Conservation Commission  
Minutes January 20, 2016 12:30 PM Town Hall  
FINAL

Chilmark Conservation Commission Questions  
January 12, 2016

Sheet C1  
 Parking and Restoration Plan  
 Chilmark, Mass.  
 Prepared for  
**The Town of Chilmark**  
 December 17, 2015 Scale 1" = 30'  
 01-19-2016: supplemental information sheet

Response of Squibnocket Farm, Inc. to Chilmark Conservation Commission Questions

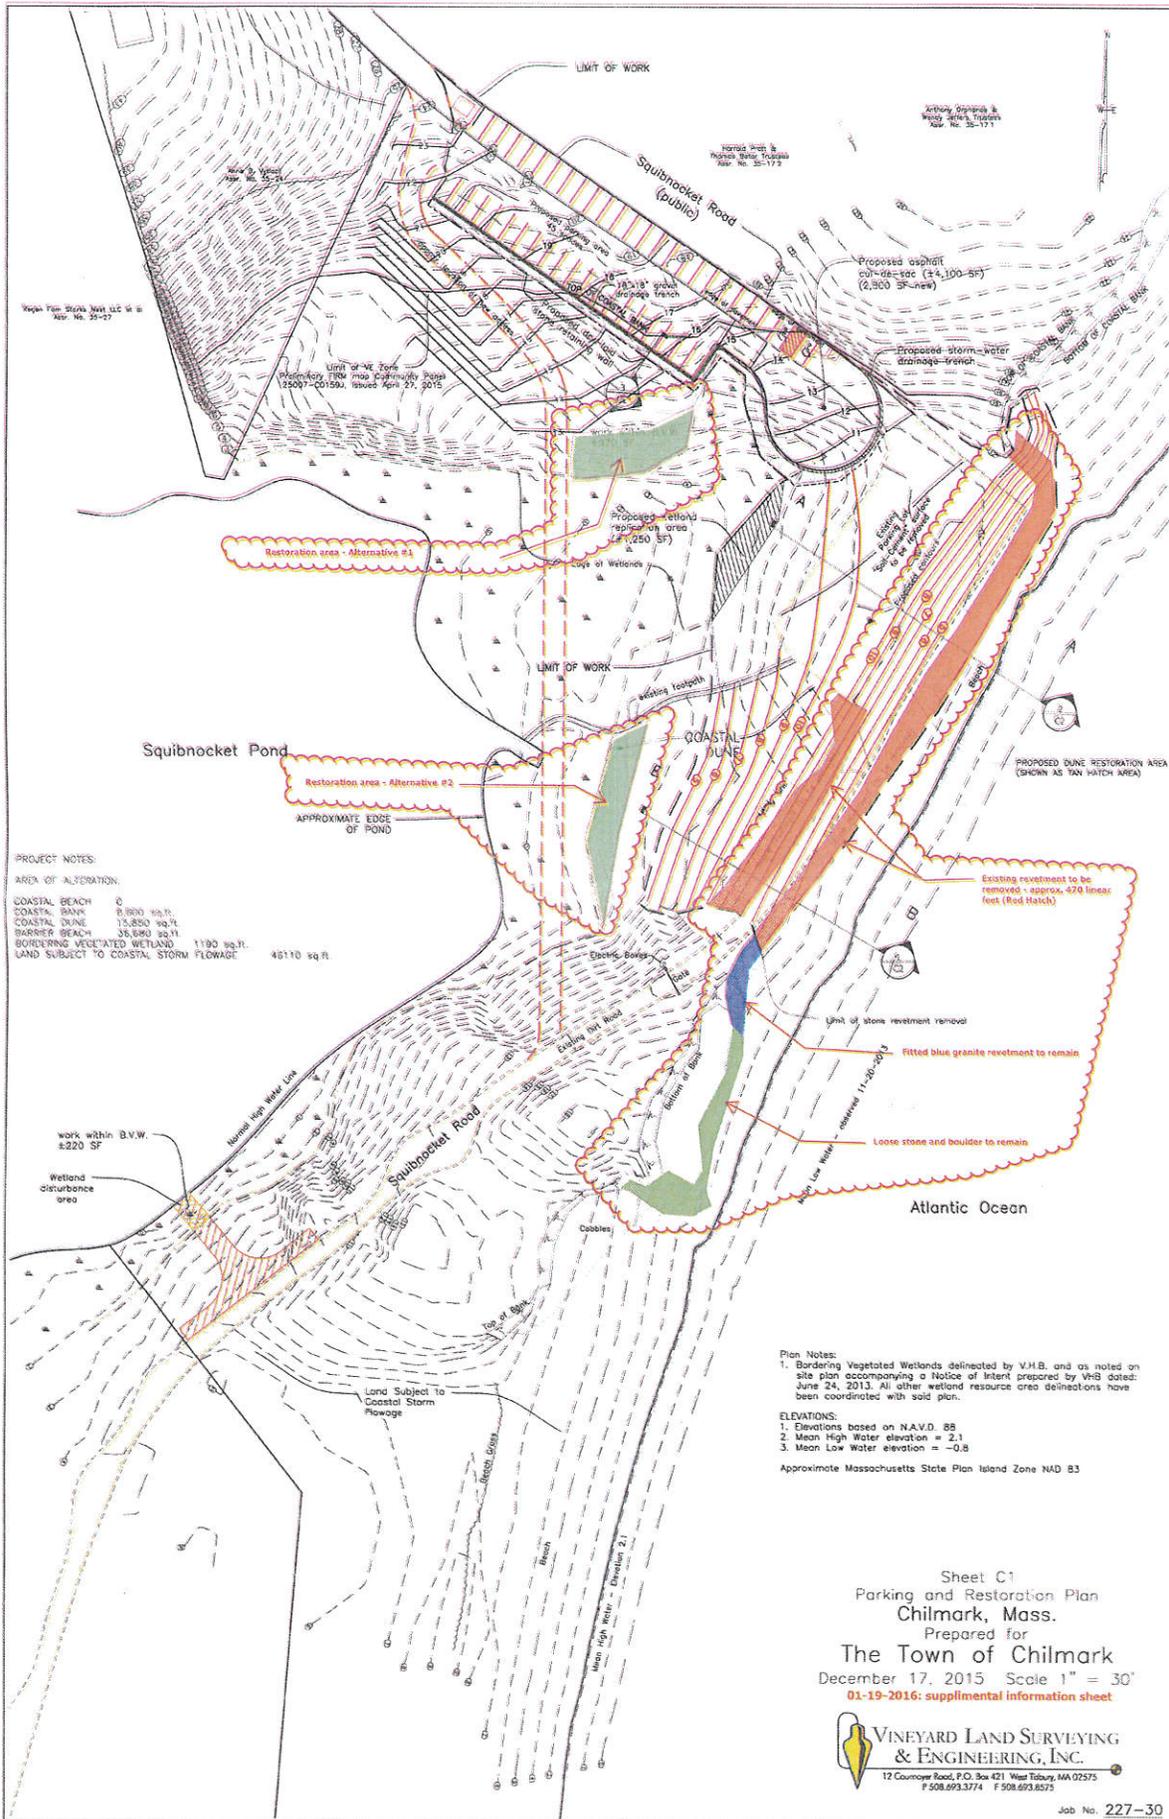
1. How many feet of parking lot revetment are being removed? **Approx. 470 ft.** Once the parking lot revetment is removed, how many feet westward does the remaining revetment extend? **Approx. 35' of blue granite and a total of approx. 140' of stone will remain in place.** Please indicate both the removed and remaining revetment on a map. **See attached plan**

4. Were alternative sites for the replication area considered? If so, which ones and why were they considered inferior? **Yes, alternative sites were considered but were found inferior (see attached sketch). Alt. 1 was rejected due to added disruption to an area outside of the project limits. Alt. 2 was rejected due to the dis-similar wetland types. Most of the displaced wetland borders a freshwater spring adjacent to Squibnocket Road. Alt. 2 is a low lying area adjacent to the pond consisting primarily of marsh grasses and fringe marsh vegetation. The proposed replication area was chosen to limit disturbance to an area within the project boundary and to provide similar wetland species and characteristics to those that are being displaced.**
